**City of Portland, Maine - Building or Use Permit Application**

Permit No: 07-0372	Issue Date:	CBZ: 179-B-0-2 179 B001001
-----------------------	-------------	----------------------------------

Past Use: Vacant Land	Proposed Use: Single Family 28' x 42' w/ detached 22' x 22' garage	Permit Fee: \$890.00	Cost of Work: \$87,000.00	CEO District: 3
Proposed Project Description: 28' x 42' w/ detached 22' x 22' garage		FIRE DEPT: <input type="checkbox"/> Approved <input type="checkbox"/> Denied	INSPECTION: Use Group: R-3 Type: SF IRL 2003 Signature: 5/15/07 [Signature]	
		PEDESTRIAN ACTIVITIES DISTRICT (P.A.D.) Action: <input type="checkbox"/> Approved <input type="checkbox"/> Approved w/Conditions <input type="checkbox"/> Denied Signature: Date:

CHECK-LIST AGAINST ZONING ORDINANCE permit # 07-0372

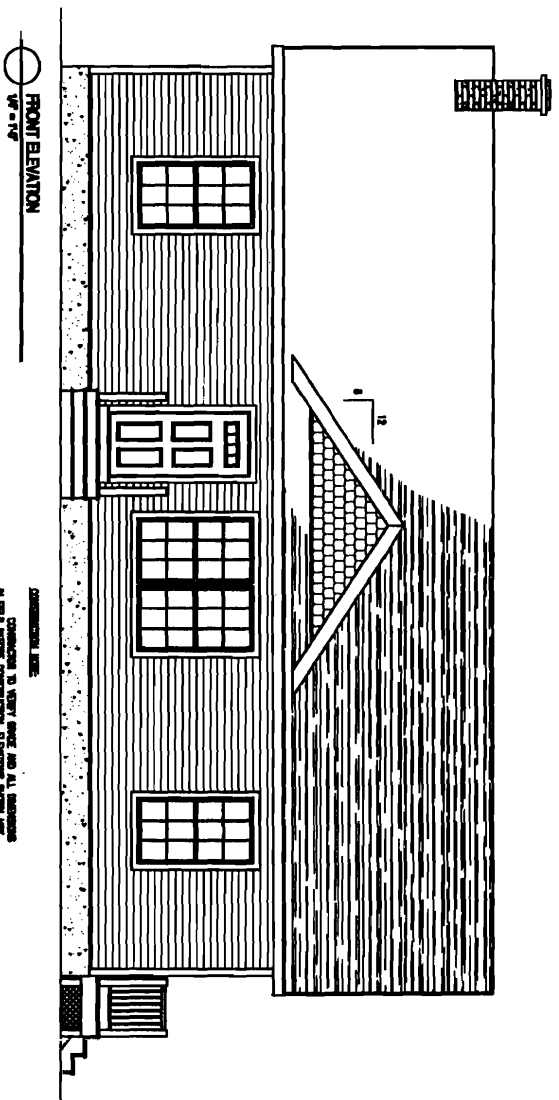
Thanks John. What is the exact distance between the building and the extension of the property line?

0.23 feet
